MEMO TO: Prospective Bidders
FROM: Kimberly Toon, Purchasing Manager
SUBJECT: **Addendum #3:** NC Veterans Park Phase II
DUE DATE AND TIME: **APRIL 24, 2026; 2:00 p.m.**

A. The Bid Documents are hereby modified by this Addendum #3 dated April 16, 2026. To include the following:

North Carolina
Veterans Park
Phase II
300 Bragg Blvd.
Fayetteville, NC
28301

Owner
City of Fayetteville
433 Hay Street
Fayetteville, NC 28301

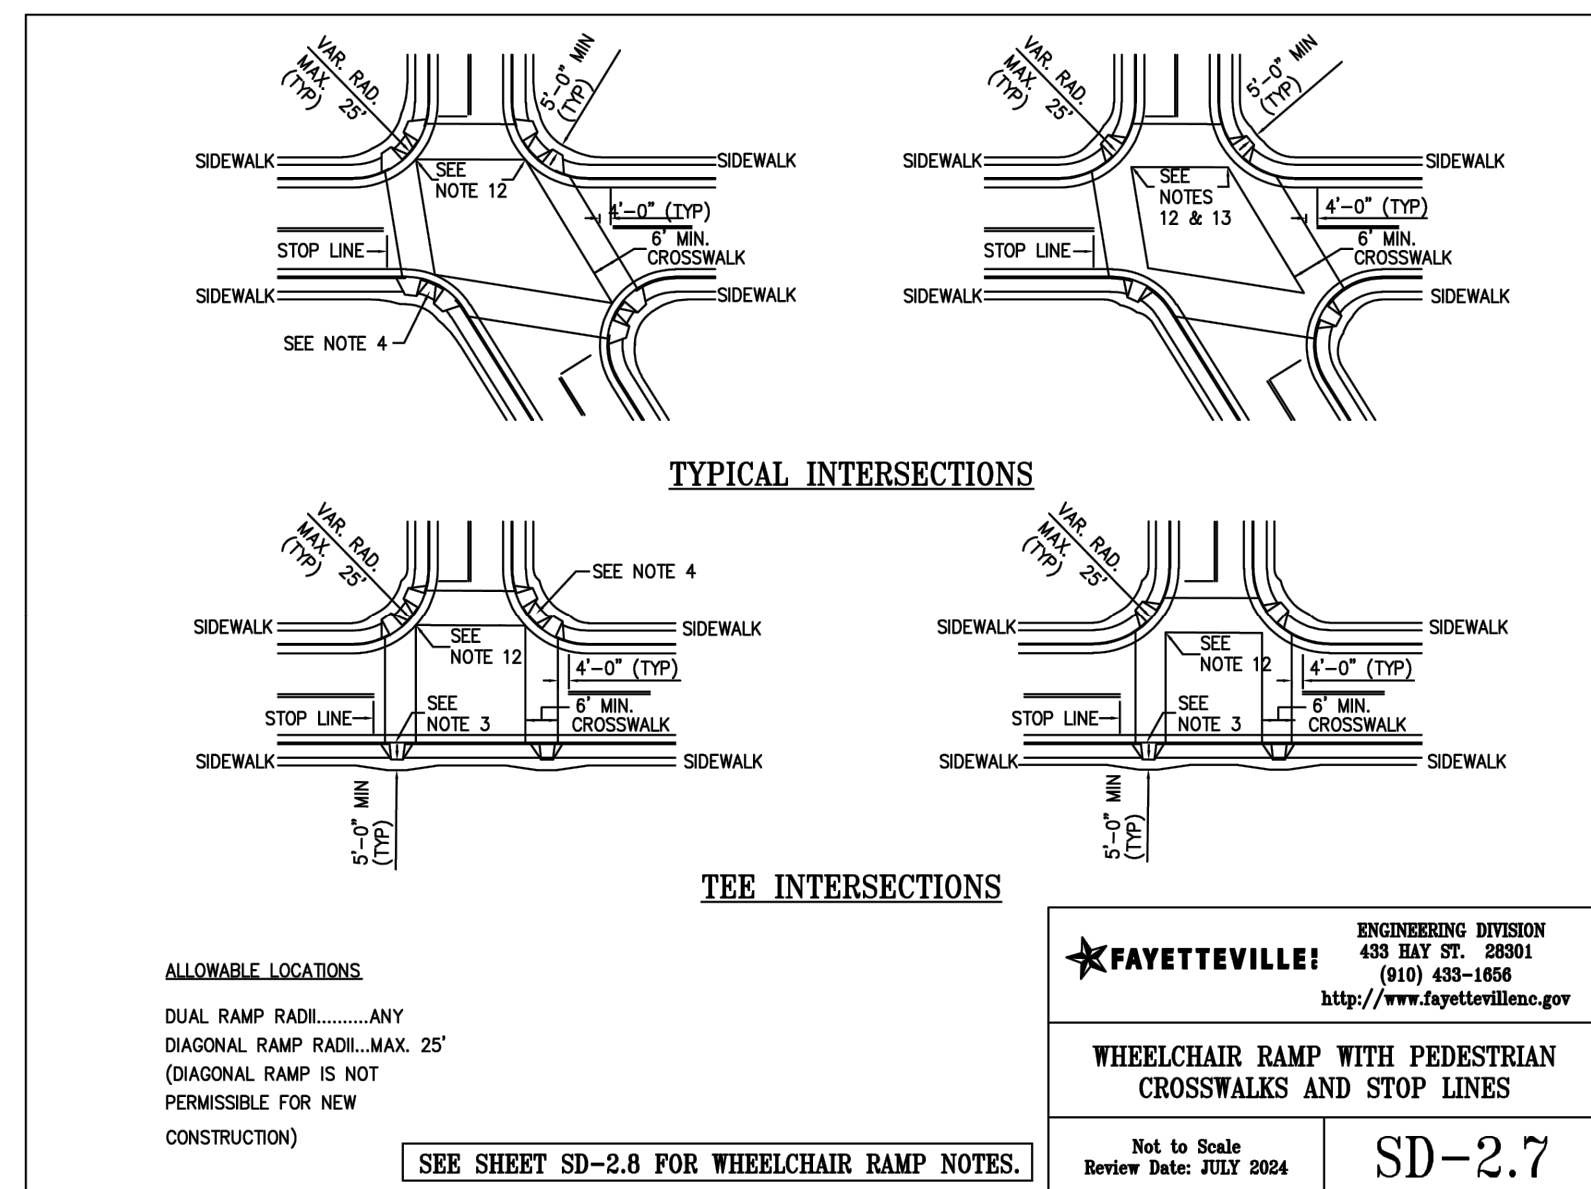
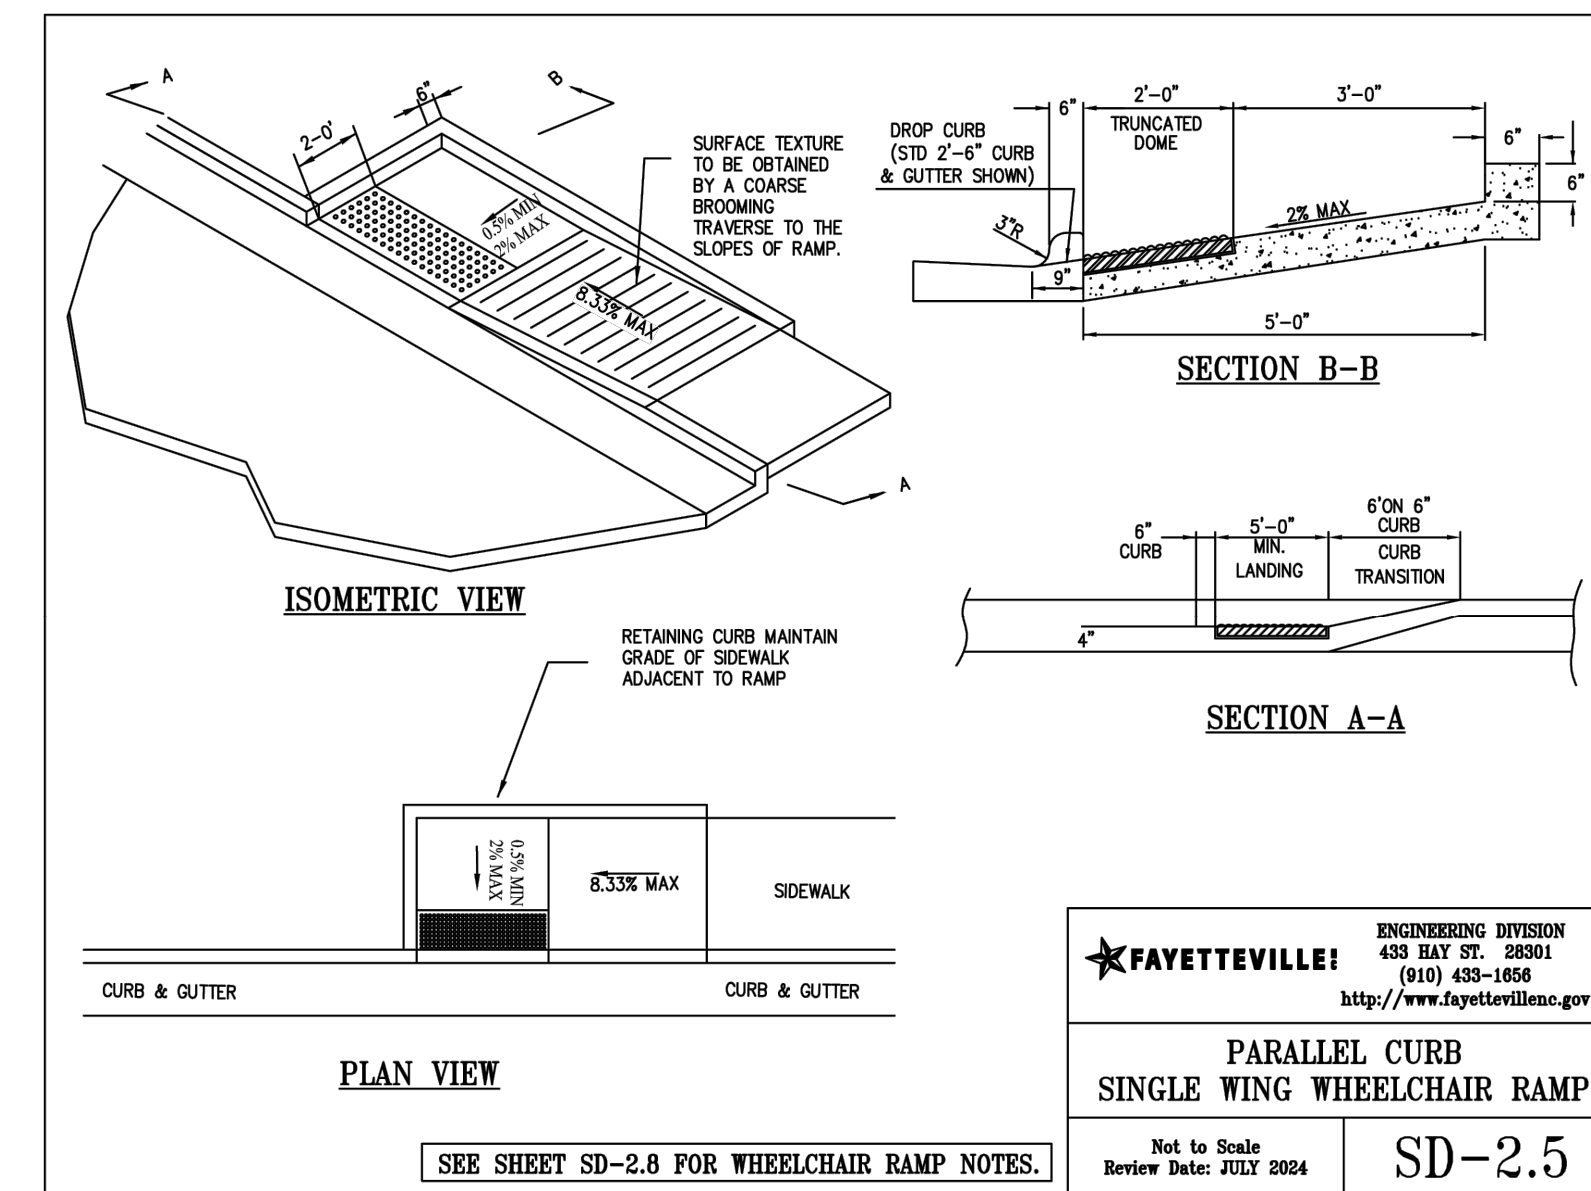
13. **Question:** SD-10 on sheet C-503 (Handrail)—where is this located on the plans?

Answer: This detail has been updated and issued in this Addendum.

D1 L-702 3/4" = 1'-0"

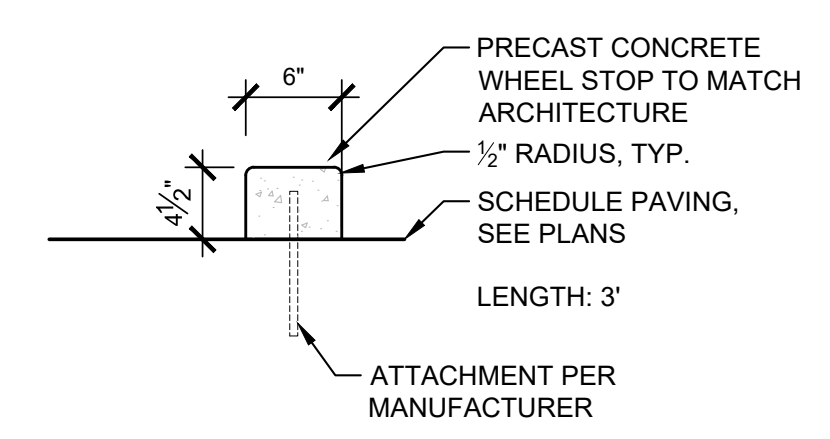
6. **Question:** Sheet L-702 Site details references detail A1 metal edging-Asphalt edging. However, I do not see A1 referenced anywhere on site features sheets L201-L206. Can you please clarify where you would like the permaloc asphalt edging installed.

Answer: This condition is no longer in the project. Refer to re-issued sheet **L-702** for clouded changes.

A1
L-701
ASPHALT PAVING (HEAVY DUTY)
1 1/2" = 1'-0"

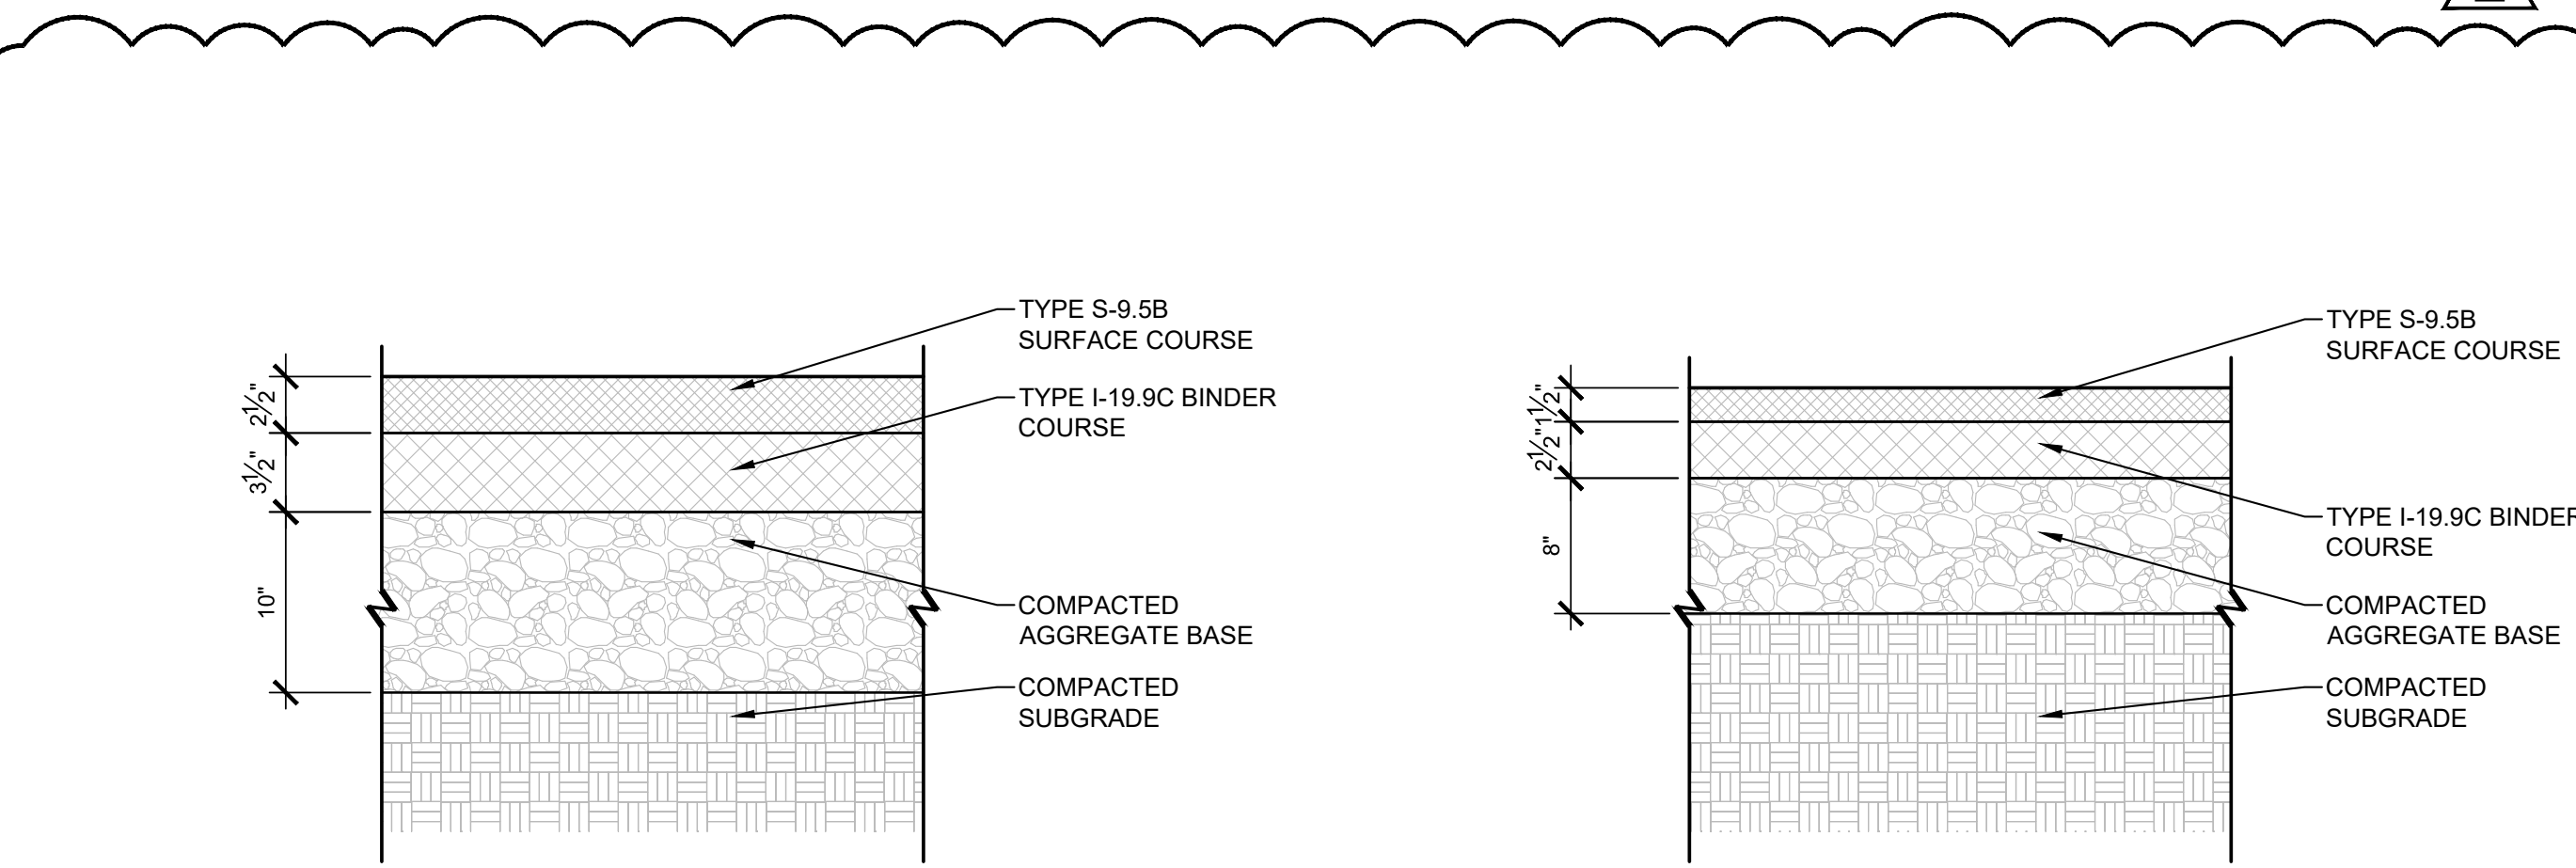
17. **Question:** According to NCDOT spec, the minimum depth for I19.0C Binder is 2.5", but the detail only shows 2". The B25.0C at 3" and S9.5B at 1" are good. Let me know how to proceed with figuring it.

Answer: This detail has been updated and issued in this Addendum.

SHEET NUMBER
L-011

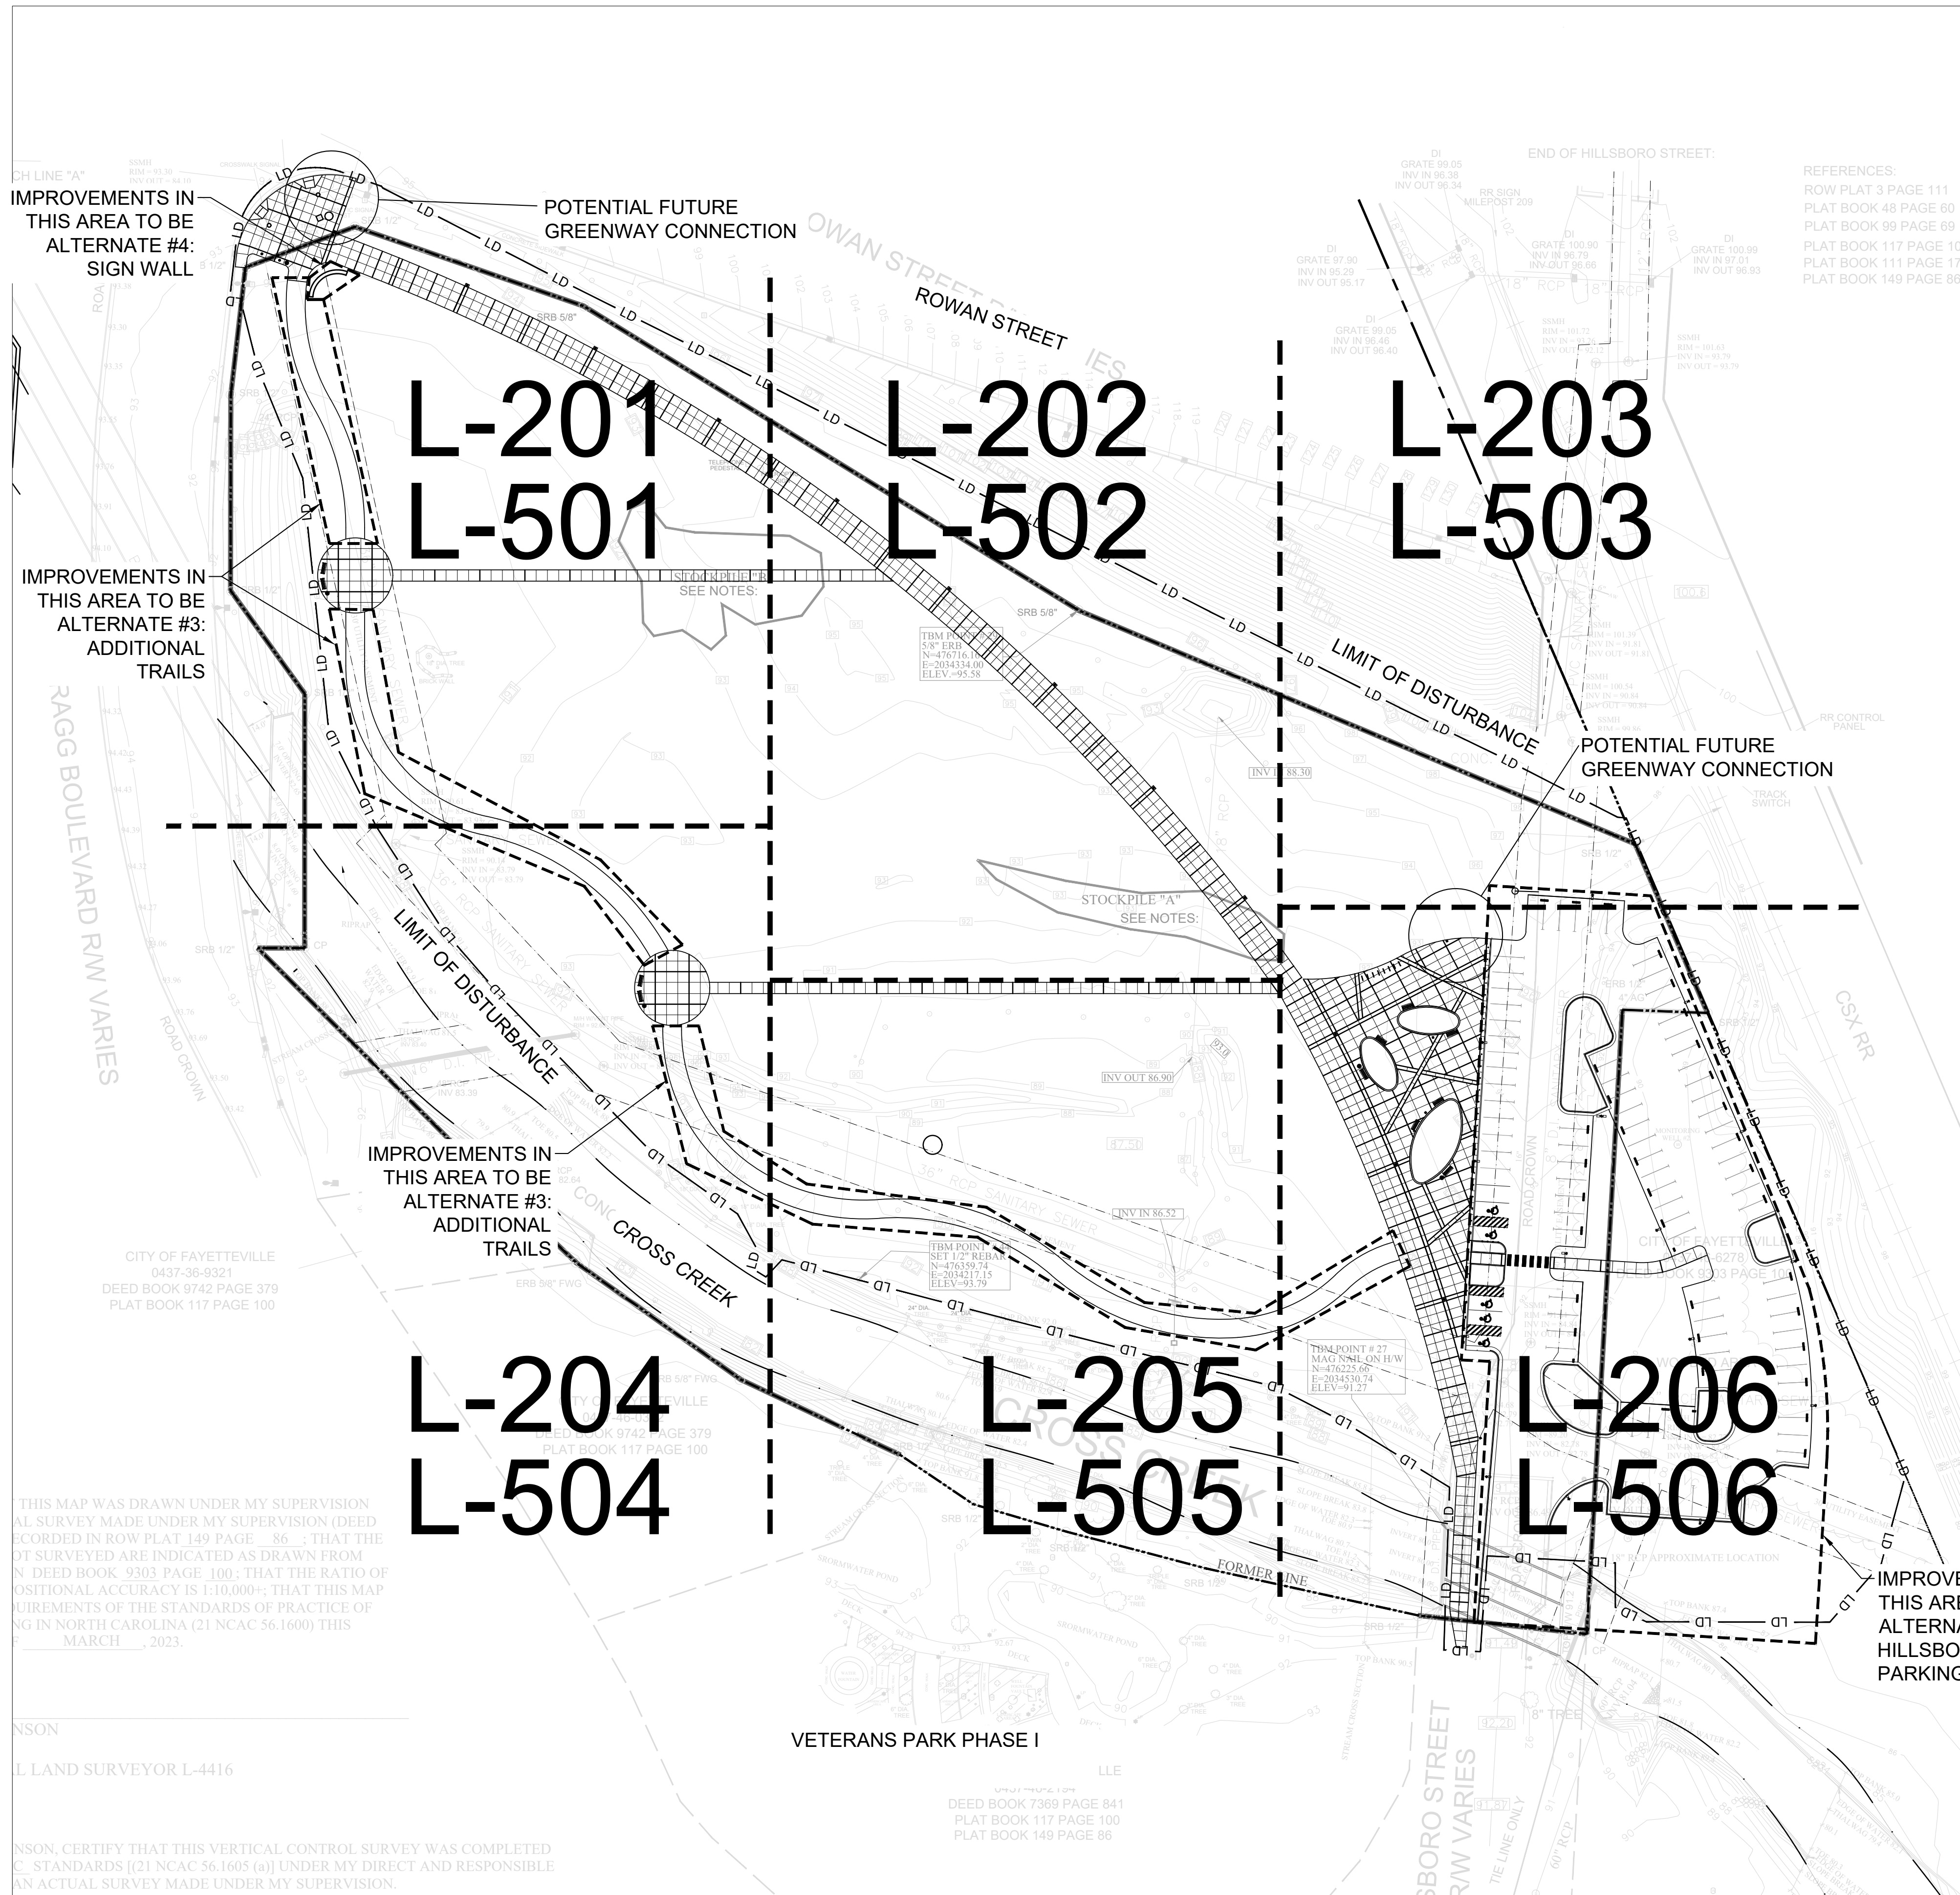
15. **Question:** Heavy Duty paving area appears to be very close to the bid item amount (Bid-34,838 SF / Takeoff-34,676 SF). However, the Pedestrian Paving (LD) is off quite a bit (Bid-11,644 SY / Takeoff-8,769 SF). See attached and let me know if you have any idea where the remaining pavement area may be or if they just missed the takeoff.

Answer: This quantity has been updated and issued in this Addendum.
